SUBJECT: FOLLOW-UP ON DECISION REGARDING ADDITIONAL SOIL BORINGS AND TESTING - MIDLAND PLANT, UNITS 1 AND 2

SUBJECT: Report on Review of Geotechnical Aspects of the Seismic Safety
of Midland Nuclear Power Plant

SUBJECT: Visit to Midland Michigan NPP on 27-28 February 1980, A Review of the Midland Plant Units 1 and 2 FSAR (Including Revisions 1-27)

LINE NO. 26" OHBC-54

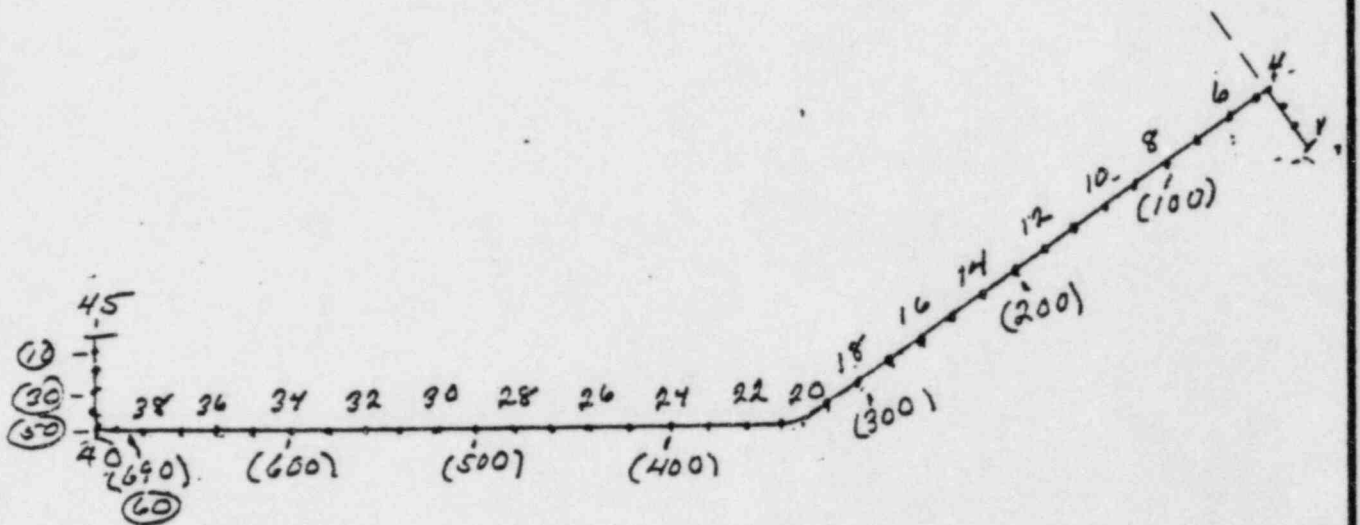
* JULY 79 DATA THIS AREA OF LINE NOT INCLUDED IN BECHTEL REPORT
 + THE DISCREPANCY BETWEEN THE BECHTEL AND ETEC ANALYSIS IN THIS AREA MAY BE DUE TO THE FACT THAT THE CONFIGURATION IN THIS AREA WAS UNCLEAR AND STRESS INDICES USED
